AGENDA

Development Commission

7:00 PM - Wednesday, March 16, 2016
Council Chambers, 135 East Sunset Way, Issaquah WA

- a) **Continued Discussion Gateway Senior Housing**
Presented by:
Amy Tarce, Senior Planner

1. FROM NW PINE CONE DR
 AFTER

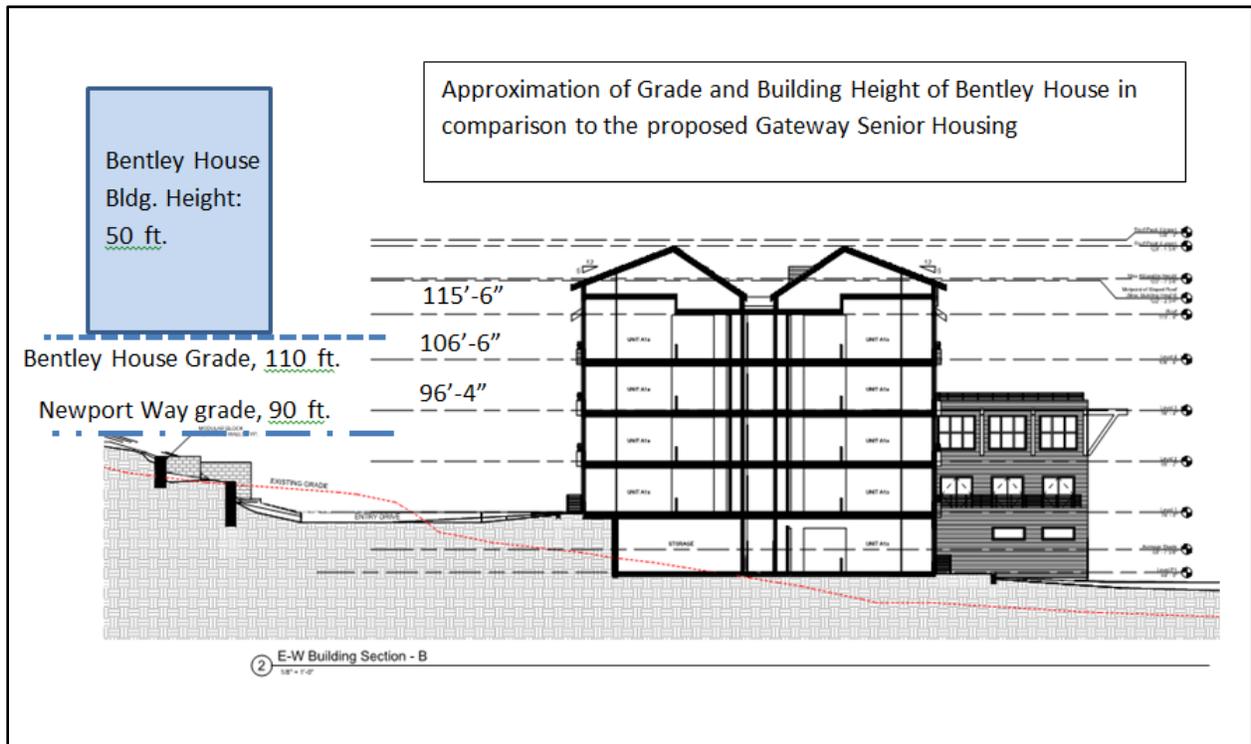
The current height regulations for this property (VR-Residential) allow building heights of 48 – 65 feet with bonus density, or 54 feet if the building provides parking under the building. The Applicant has provided parking under the building and as such, the maximum height of the building proposed is 54 feet, as provided in the CIDDS. At 54 feet, and with the grades descending from Newport Way to the interior of the site, only the top 3 floors of the building rise above the grade of Newport Way. It should also be noted that height regulations applicable to this property prior

to the adoption of the Central Issaquah Plan in the 1990s, allowed building heights of 40 to 65 feet, through an Administrative Adjustment of Standards (IMC18.07.355). The proposed height of the Gateway Senior project would have been allowed under the former zoning standards.
